November 2018
FL766A-C
NHTSA #18V-191
Transport Canada #18-190
REVISED NOTICE

Subject: Western Star Power Cable Studs

Models Affected: Specific Western Star 4700, 4900, 5700, and 6900 model vehicles manufactured September 12, 2016, through February 6, 2018.

REVISIONS: Corrected parts are now in stock and the Replacement Parts Table has been updated. Please handle vehicles in FL766 as follows:

Fig. 1, Power Cable Stud Connector Location

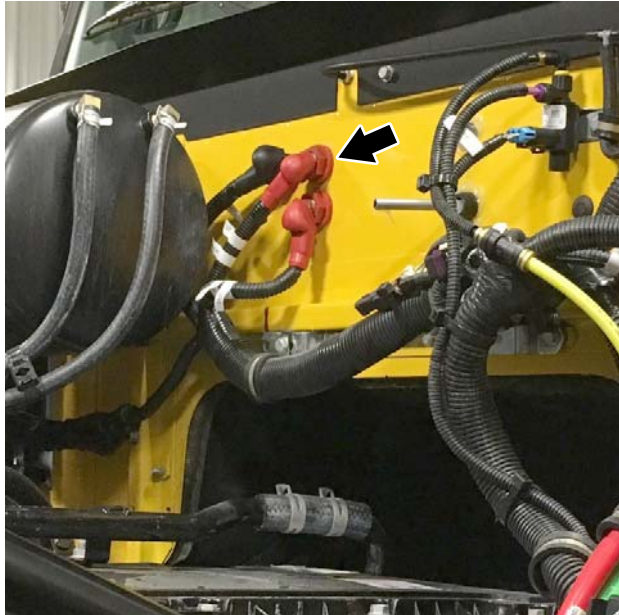
1. Open the hood and locate the three or four power cable stud connectors on the front wall. See [Fig. 1](#).
2. Pull back the covers on the power cable stud connectors. See [Fig. 2](#). Inspect each cable stud to make sure at least one thread protrudes past the plastic nut. See [Fig. 3](#) and [Fig. 4](#).

Fig. 2, Removing Connector Protective Cover

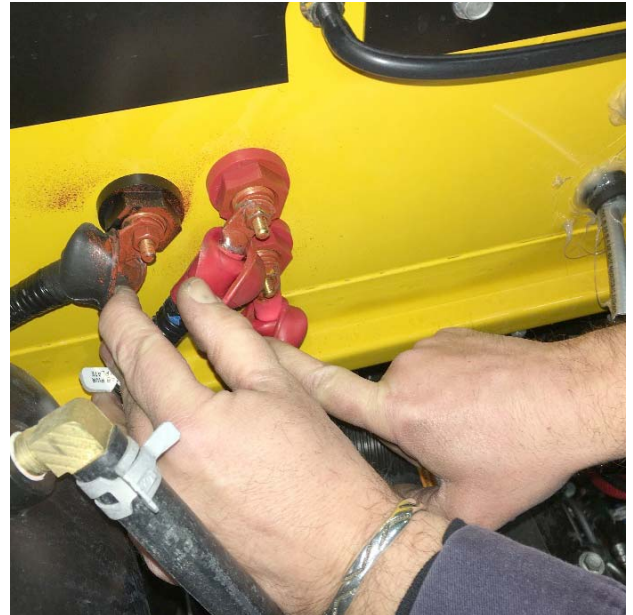
If at least one thread does **NOT** protrude past the plastic nut, the installation is **INCORRECT**. Proceed to "Power Cable Stud Replacement."

If at least one thread protrudes past the plastic nut, the installation is **CORRECT** and the recall is complete. Continue with the next step.

Fig. 5, Location of Front-Wall Power Terminals (inside the cab)

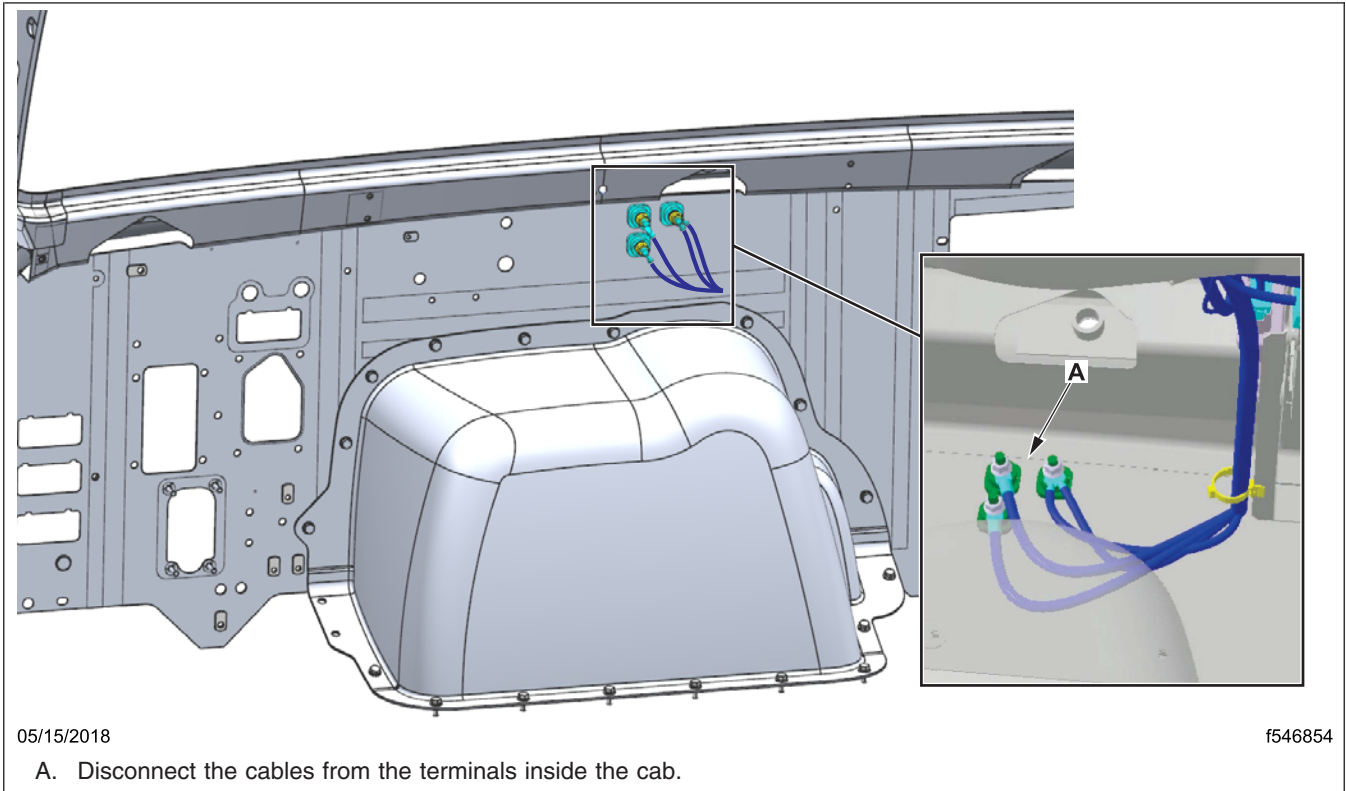
4. Disconnect the cables from the terminals inside the cab. See [Fig. 5](#)

5. Disconnect the cables from the terminals on the outside of the front wall.
6. Remove the plastic nuts and the studs.
7. Remove the old power cable studs and replace them with the new power cable studs.
8. Fully seat each stud in the square hole.
9. Tighten the plastic nuts 60 to 84 lbf-in (680 to 950 N-cm). Make sure at least one thread is exposed past the plastic nut.
10. Connect the cables to the terminals on the outside of the front wall.
11. Connect the cables to the terminals inside the cab.
12. Install the dash. Refer to *Western Star Workshop Manual*, **Section 60.06, Subject 110**.
13. Clean a spot on the base label (Form WAR259). Write the campaign number, FL766, on a blank red completion sticker (Form WAR260) to indicate the work has been completed and attach it to the base label.
